Computer Monitors Service Bulletin

Model: GDM20SE1, GDM17SE1

No. 89R1

Subject: Failure of Q511 on D Board due to CRT Arcing Date: August 8, 1995

Board, Part No. Suffix -11 to -42

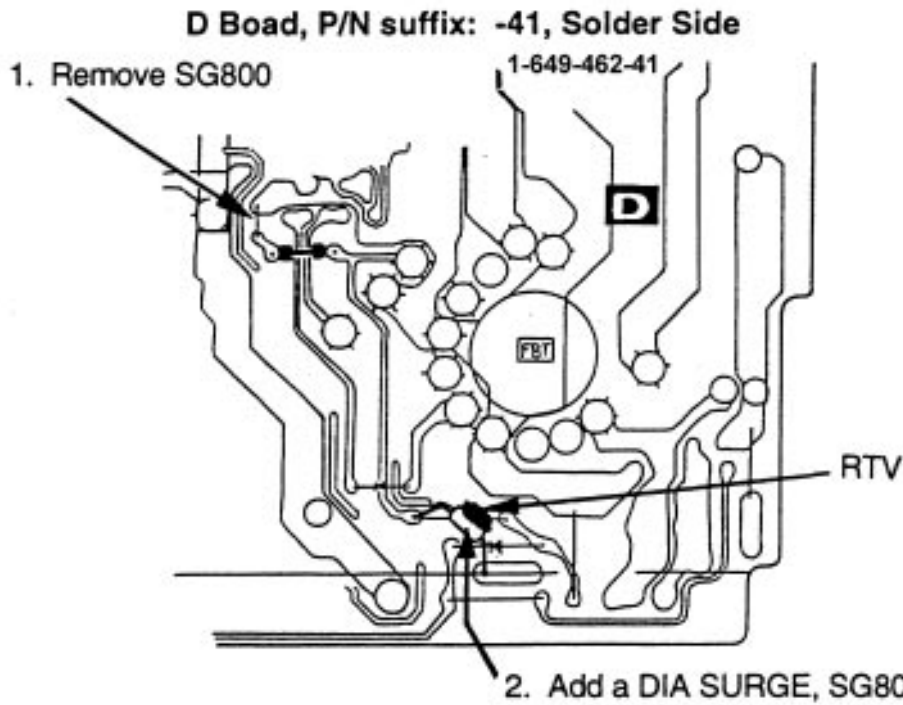
Procedure to remove SG800 and add SG801. See Figure below.

1. Remove SG800 Spark Gap.
2. SG801 will be soldered on the Soldering side of the D Board. Cut the leads of the SG801 as necessary. Solder one lead of SG801 to the land of R825. Solder the other lead of SG801 to the land of the Heatsink as shown.
3. Fix the body of SG801 to the D Board on the board near the FBT ground with RTV or similar adhesive.

Board, Part No. Suffix -11 to -042

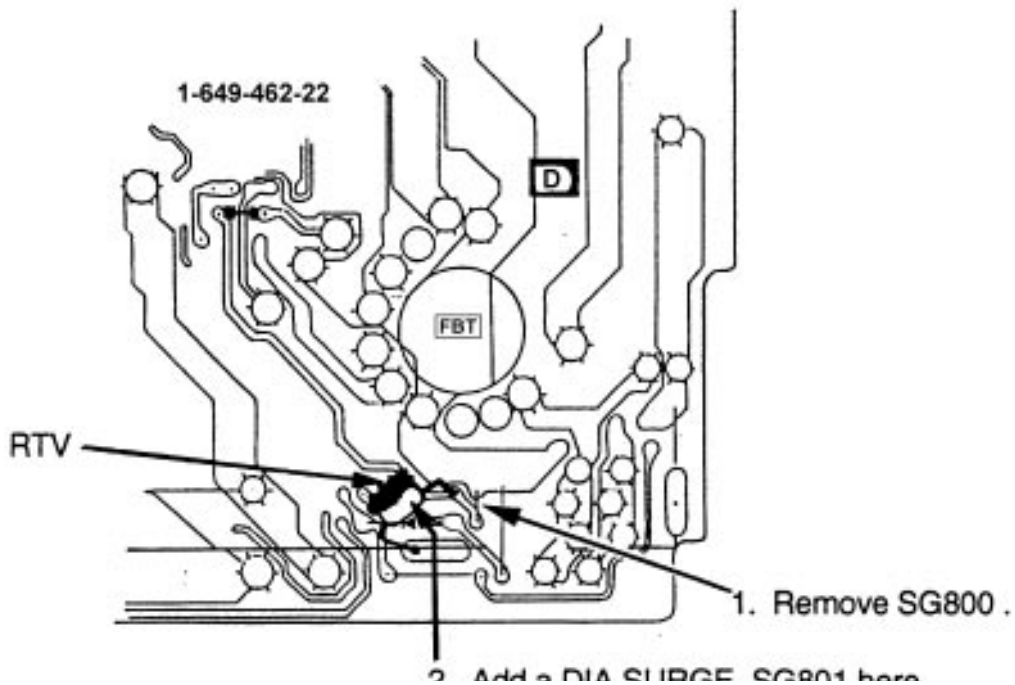
Perform modifications as shown according to the applicable foil pattern.

For other foil patterns, perform modifications according to the schematic changes described as follows. cont.

Schematic diagram changes.

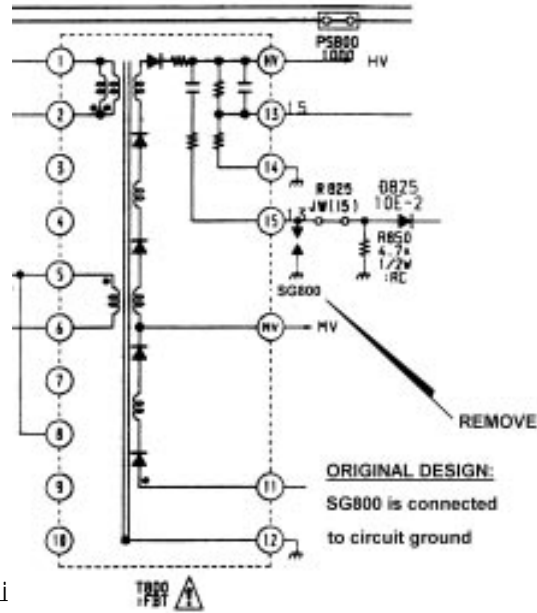
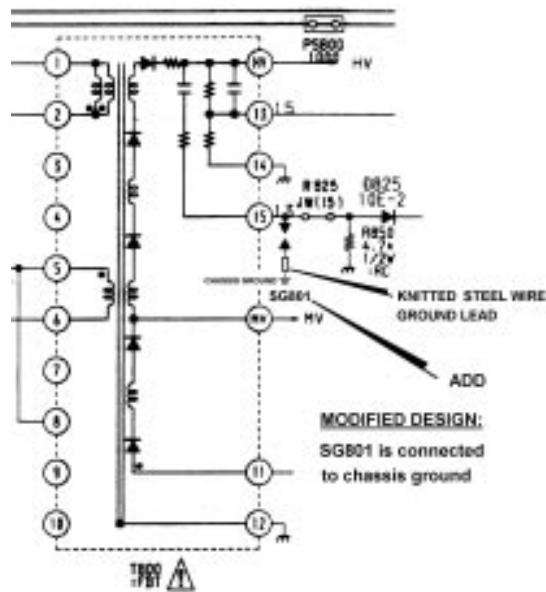
Original Design: SG800 is connected to circuit ground.

Modified Design: SG801 is connected to chassis ground.

Original Design: SG800 is connected to circuit ground.
